| <b>Re: Recall Campaign Launch Notification<br/>Model 907 (Sprinter)<br/>Model Years 2020<br/>Inspect Swivel Seat Wiring Harness Routing</b> | DATE: August, 2021   |

| <b>Campaign No. :</b>   | <b>Campaign Desc. :</b>  | <b>Inspect Swivel Seat Wiring Harness Routing</b> |
| <b>2021070031</b>   | <b>VS3DREHSEL</b>  |   |

SUBJECT: **Model 907 Sprinter, Model Year 2019-2021**  
**Inspect Swivel Seat Wiring Harness Routing**

**Shown on driver's seat with code SF1 (Electrically adjustable driver's seat) and code SR8 (Driver's seat rotating frame)**

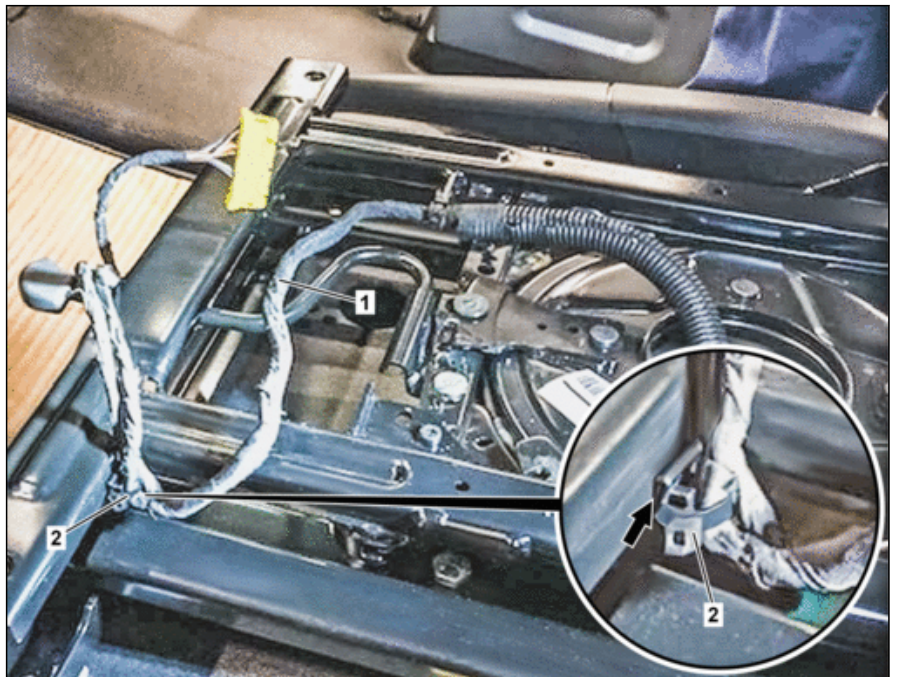
| 3 | Subsequently adapt line installation and attachment of wiring harness (1) to respective rotating seat. | <p><b>i</b></p> <p>To do so, check if the wiring harness (1) is correctly fastened to the respective rotating seat frame using a cable tie with retaining clip (2).</p> <p>The wiring harness (1) must be positioned in the corner (arrow) of the rotating seat frame, as shown in the picture, and fixed in place using a cable tie with retaining clip (2).</p> <p>If cable tie with retaining clip (2) is not present,</p> <p style="text-align: center;">↓</p> <p>subsequently fasten wiring harness (1) to rotating seat frame using retaining clip (2). To do so, position wiring harness (1) along cable tie with retaining clip (2) in corner (arrow) of rotating seat frame. See figure.</p> <p>If cable tie with retaining clip (2) is present,</p> <p style="text-align: center;">↓</p> <p>position wiring harness (1) correctly on rotating seat frame. To do so, position wiring harness (1) along cable tie with retaining clip (2) in corner (arrow) of rotating seat frame. See figure.</p> |  |
